VPNPD-94-087

September 9, 1994

DOCKETS 50-266 AND 50-301
CLARIFICATION OF REQUEST FOR EXEMPTION FROM
THE REQUIREMENTS OF 10 CFR 50, APPENDIX R, SECTION III
FOR THE AUXILIARY FEEDWATER PUMP ROOM
POINT BEACH NUCLEAR PLANT, UNITS 1 AND 2

Attachment 1

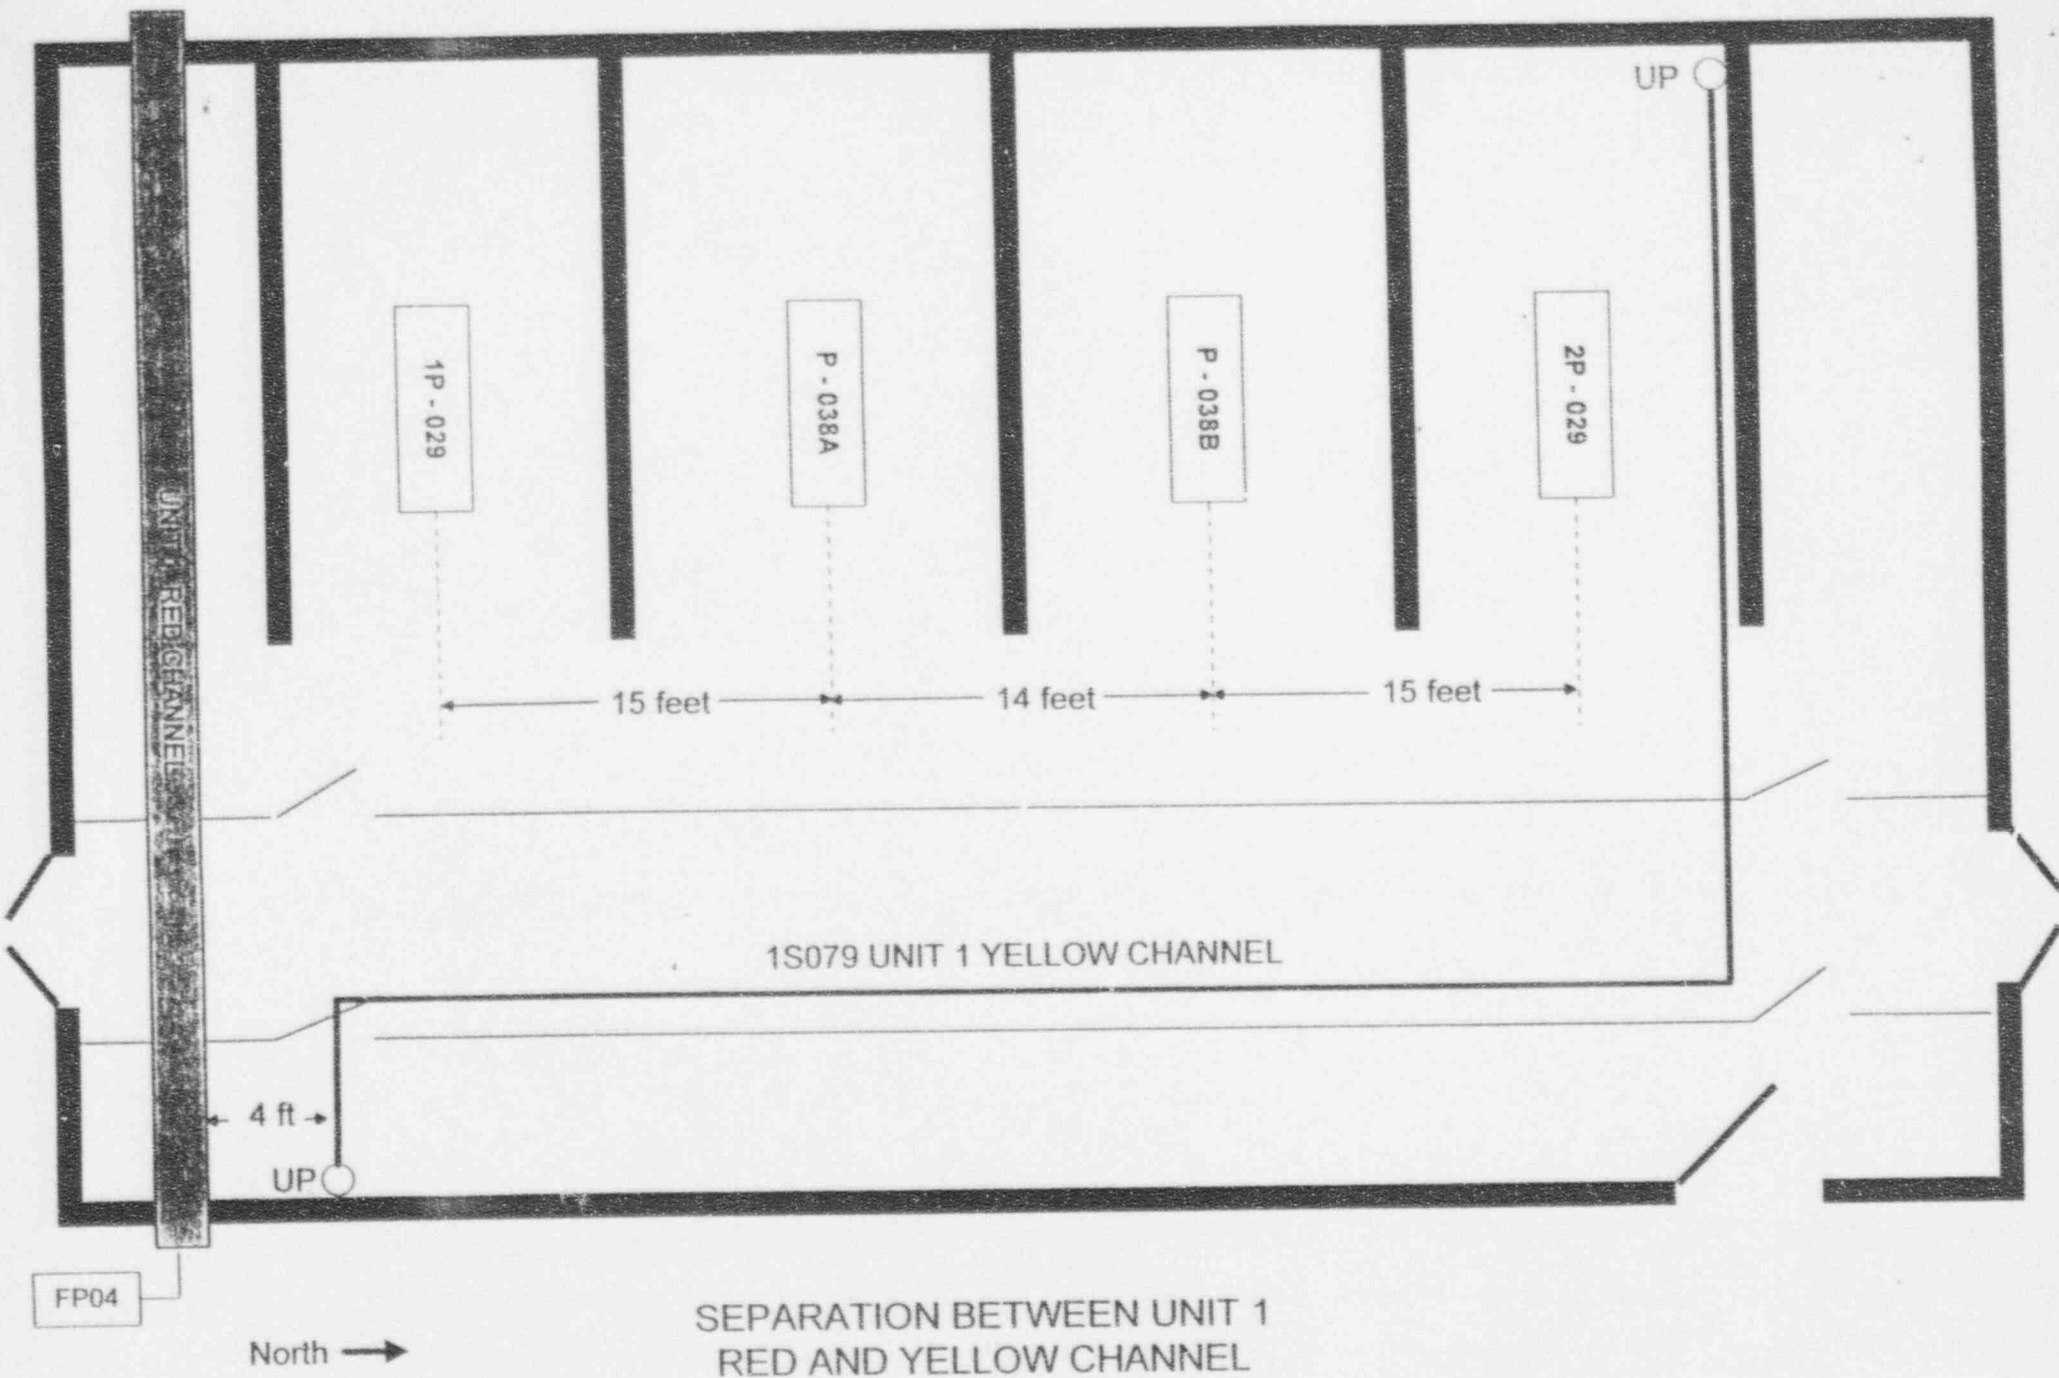
In the August 5, 1994, submittal, we stated that conduit 1S079, associated with the Unit 1 yellow channel of safe shutdown instrumentation, does not meet the twenty-foot horizontal separation requirements of Section III.G.2.b of Appendix R. Conduit 1S079 is located within approximately four feet of the Unit 1 red channel, the closest redundant instrumentation channel. Unit 1 red channel instrumentation cables are located in cable tray FP04 as shown in Attachment 1. We also indicated our intention to modify this configuration by either rerouting conduit 1S079 to ensure that twenty-foot separation is achieved or by providing an equivalent means of separation.

However, in order to maximize the number of instrumentation channels available following a fire in the auxiliary feedwater pump room, it is prudent to perform the modification on conduit 1S079. Completion of this modification will ensure that either the Unit 1 red or yellow channel is available following a fire in the auxiliary feedwater pump room, providing added operational flexibility. The information concerning the modification was included in the August 5, 1994 submittal in order to ensure that the fire area's final configuration was described in the request for exemption.

Additionally, the configuration of conduit D01-2 is discussed in the original request for exemption. This conduit is approximately four feet in length and contains power cables for one channel of safe shutdown instrumentation. This conduit is separated by a horizontal distance of approximately sixteen feet from the other required instrumentation cables in cable tray FU01. This conduit is also located in the separation space between cable trays FR02 and FU01 as shown in Attachment 2.

Following our submittal of August 5, 1994 request for exemption, we determined that it was appropriate to wrap conduit D01-2 using fire barrier material with a one-hour fire rating to ensure that the conduit is protected from a fire in the fire area. This conduit will be wrapped with the E-50 series of fire barrier material manufactured by the 3M Corporation. The conduit wrap will be installed in accordance with the manufacturer's recommendations.

ATTACHMENT 2

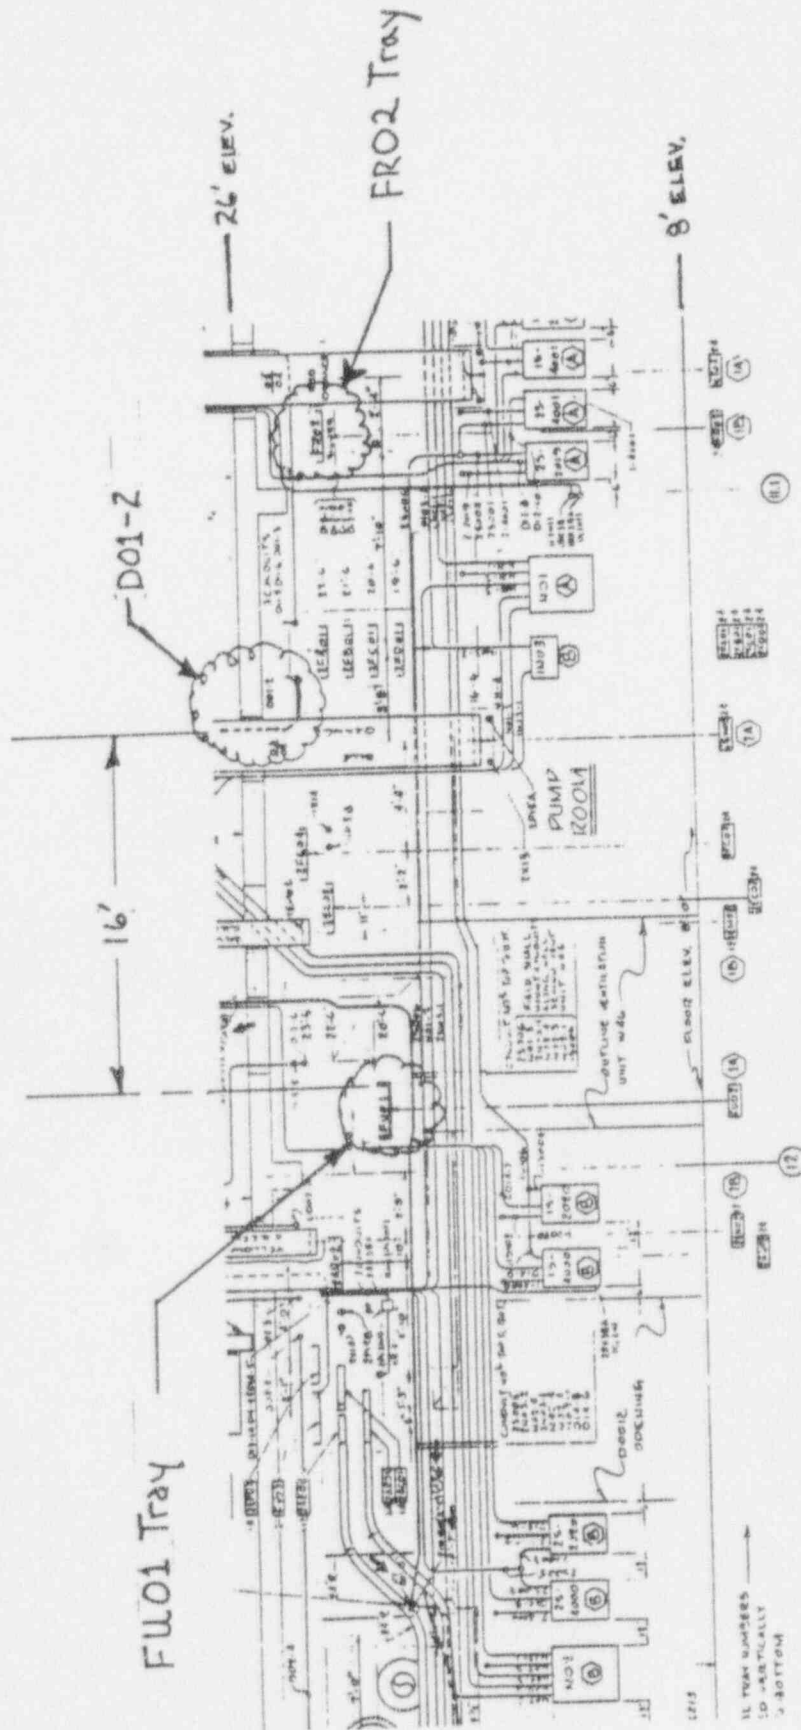
In addition to the clarifications to the "Plant Instrumentation" section, this letter is being submitted to modify information contained in the "Cable Separation in Fire Area A23" section of the request for exemption. In the August 5, 1994 submittal, we described four cable trays that were installed in the auxiliary feedwater pump room as part of the Diesel Generator Addition Project. Three of the four cable trays present an intervening combustible between redundant divisions of Appendix R safe shutdown components. The configuration of these cable trays is shown in Attachment 3. In order to minimize the impact of these three cable trays, we committed to perform modifications involving the installation of sheet metal tray covers, ceramic fiber blankets, and cable tray fire breaks. These modifications, however, were only being performed on the portions of the three cable trays situated between redundant divisions of Appendix R safe shutdown components located in cable trays FR02 and FU01.

modifications being performed on the three cable trays. We are now installing sheet metal tray covers on the top and bottom of cable tray GG01-GG04 along its entire length in the auxiliary feedwater pump room. Additionally, sheet metal tray covers will be installed on the top of cable trays GN01-GN03 and GW01-GW03 along their entire lengths in the auxiliary feedwater pump room, with tray covers also being installed on the bottom of these cable trays for the portions of their runs that are not shielded by the three-hour, fire-rated tunnel. A single layer of ceramic fiber blanket will be installed on the top of the cables in the three cable trays under the sheet metal covers, and cable tray fire breaks will be installed, as needed, to prevent a fire from entering the enclosed portion of the cable trays. We believe that this revision is an improvement on the previous cable tray modifications that will further minimize the impact of the three cable trays as an intervening combustible.

Finally, in the August 5, 1994 submittal, we stated, in error, that cable tray GC01-GC02 would have sheet metal tray covers installed on the top and bottom of the cable tray. Tray covers are not being installed on cable tray GC01-GC02 because it does not present an intervening combustible between redundant divisions of Appendix R safe shutdown components. Therefore, as stated in the above paragraph, we intend to install sheet metal tray covers on the top and bottom of cable tray GG01-GG04. Please note this correction during your review of the August 5, 1994, request for exemption.
